Central Intelligence Agency

Reference Request for Underground Storage Tank Information—George Bush Center for Intelligence

Underground Storage Tank Replacement  
MotorPool Garage  
Langley Compound, Virginia  
Contract # WA92193TCI

✓ 6,000 gallon standard DWT-3 Type II(8) diesel brine O/C  
underground storage tank with 42 diameter sealed turbine  
enclosure Model STE42B-3

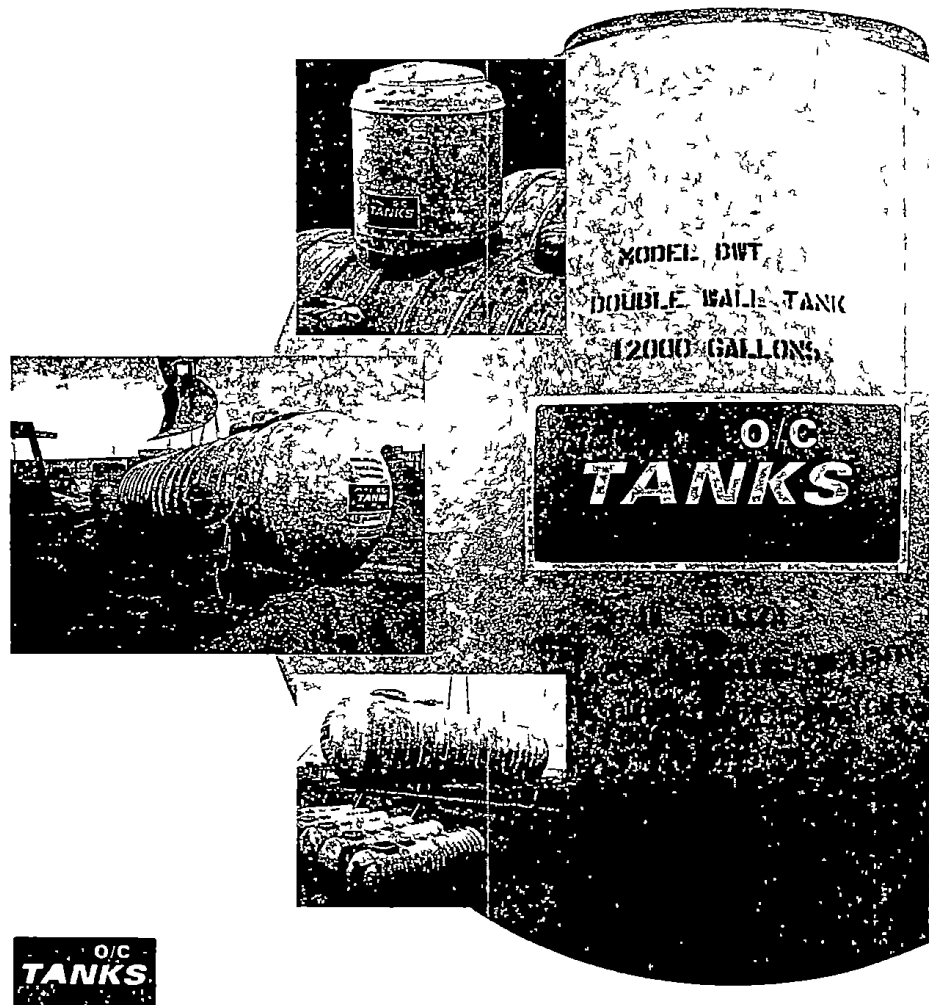
<b>CONTRACTOR</b> <b>TRI COUNTY INDUSTRIES, INC</b>	
<input checked="" type="checkbox"/> Approved	
<input type="checkbox"/> Approved with corrections, as noted on submittal data and/or attached sheet(s)	
Signature	<u>Saul Krass</u>
Title	<u>Pro. Mgr</u>
Date	<u>7-23-93</u>

<b>ENGINEERING</b> <b>DOCUMENT REVIEW</b>	
Check only one item	
<input type="checkbox"/> REVISE & RESUBMIT	
<input type="checkbox"/> RESOLVE COMMENTS & PROCEED	
<input type="checkbox"/> PROCEED	
<input checked="" type="checkbox"/> ACCEPTED	
ENGINEER	<u>Mark J. Powell</u> DATE <u>26 AUG 93</u>

- ✓ Fairfield 360WT Manhole
- ✓ OPW 53VML-0160 Ball Float Valve Assembly
- ✓ OPW 14000 Spill Container with 1DK-4080 Pull Drain

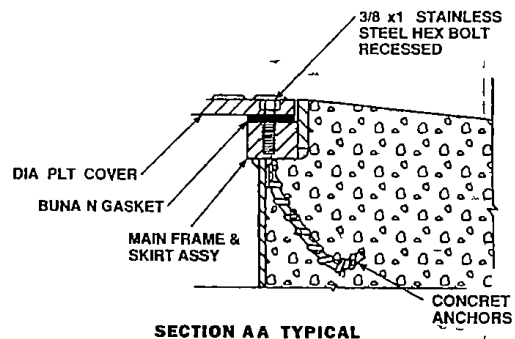
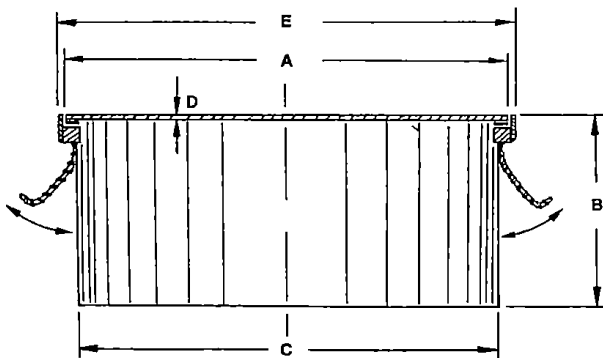
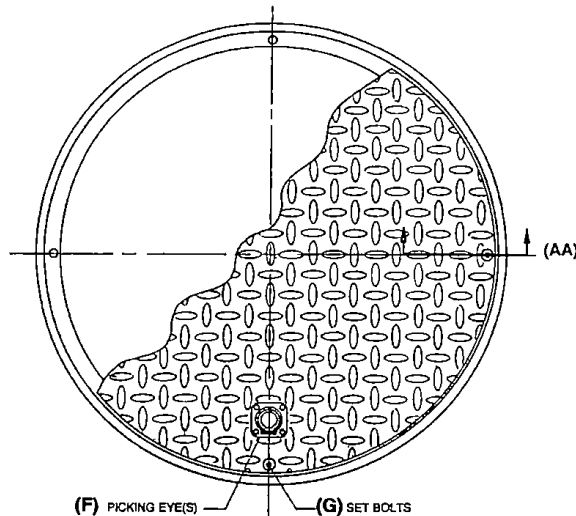
CONTRACTOR	
TRI COUNTY INDUSTRIES, INC	
✓	Approved
—	Approved with corrections as noted on submittal data and/or attached sheet(s)
Signature	<u>Saul Berry</u>
Title	<u>Proj mgr</u>
Date	<u>7-23-93</u>

ENGINEERING	
DOCUMENT REVIEW	
Check only one item	
<input type="checkbox"/>	REVISE & RESUBMIT
<input type="checkbox"/>	RESOLVE COMMENTS & PROCEED
<input type="checkbox"/>	PROCEED
<input checked="" type="checkbox"/>	ACCEPTED
ENGINEER	<u>Saul Berry</u> DATE <u>26 AUG 93</u>

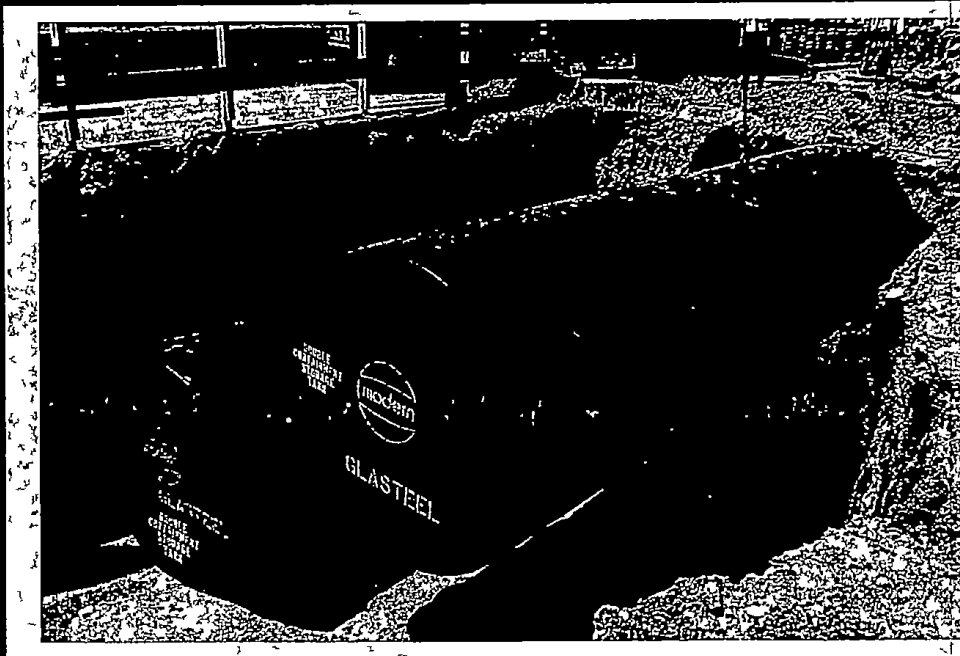
CONTRACTOR	
TRI COUNTY INDUSTRIES, INC.	
<input checked="" type="checkbox"/>	Approved
<input type="checkbox"/>	Approved with corrections as noted on submittal data and/or attached sheet(s)
Signature	<u>Saul Binsy</u>
Title	<u>Pro. Mgr</u>
Date	<u>7-23-93</u>

\* PLEASE FURNISH UL TYPE II  
DOUBLE WALL STEEL UL-58  
FIBERGLASS CLAD UST.
